**Technical Service
BULLETIN**

ENGINE HOOD RELEASE OPERATION

'00 – '01 MR2 Spyder

BODY
BO021-01

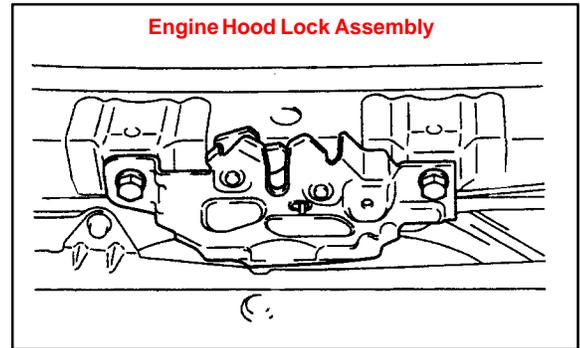
Introduction A new hood lock assembly with two new springs has been developed to improve inoperative and difficult-to-open conditions.

PREVIOUS PART NUMBER	CURRENT PART NUMBER	PART NAME
69350-17050	69350-17051	Lock Assy, Engine Hood
